**Re: Building Code of Australia Inspection & Reporting Service
Premises: Ground Floor Tenancy – 1031 Barrenjoey Road, Palm Beach NSW 2108**

The purpose of this report is to provide a written commentary regarding the ground floor awning and deck extension to the boundary associated with the café tenancy for BCA compliance purposes.

Inspection Photo - Friday, 4 June 2021

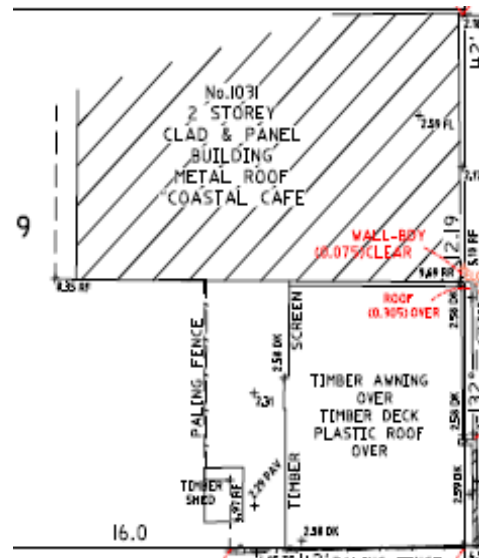
Our inspection revealed that an approximate 2.09m x 4.61m (approximately 9.6m² in area) awning addition had been made to existing awning and deck. The structure is timber framed and has been provided with translucent roof sheeting covering. Gutter and down piping have been provided – please refer to the photo for details.

In Deemed to Satisfy (DtS) BCA terms, the awning structure has external columns within 1.5m of the side boundary. Those columns are required to be fire resistant to satisfy Table 5.1 of Specification C1.1. The new roof covering to the awning additions need not be fire resistant or non-combustible. The necessary fire resistance for the external columns is noted as being not less than FRL 90/-/-.

Given that the BCA is a performance base document, the awning additions, should be considered in that light and the issue fire resistance to external timber columns should be considered through a BCA performance solution. The solution should be developed by a suitably qualified and experienced Accreditor Fire Engineer.

In addition, whilst the awning appeared to be structural adequate and in good order, a structural engineer should be engaged to provide written report stating structural qualities.
